Hi-Fi Products  
**Service Bulletin**

**Model:** SEN-190 (HST-190)

**No. 120**

**Subject:** No Sound or Oscillation During  
Tape Playback

ARRANGE HARNESS AS INDICATED

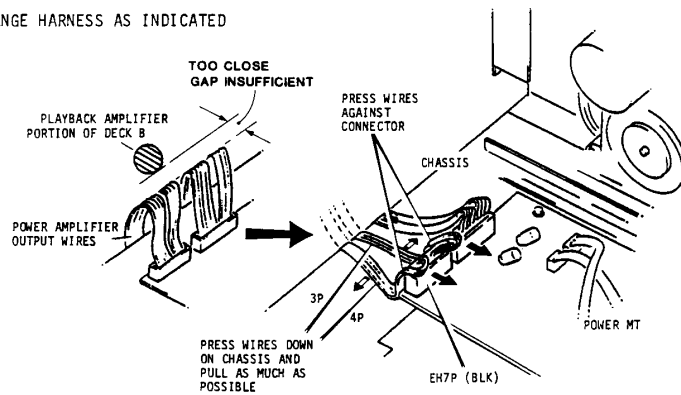
The amplifier goes into oscillation, resulting in no sound. The playback conditions are as follows:

**Cause:** The power amplifier output wires are too close to the Playback amplifier portion of Deck B, causing inductive coupling.

**Solution:** Reroute the wires so that they are as far away from this position of the PCB as possible.
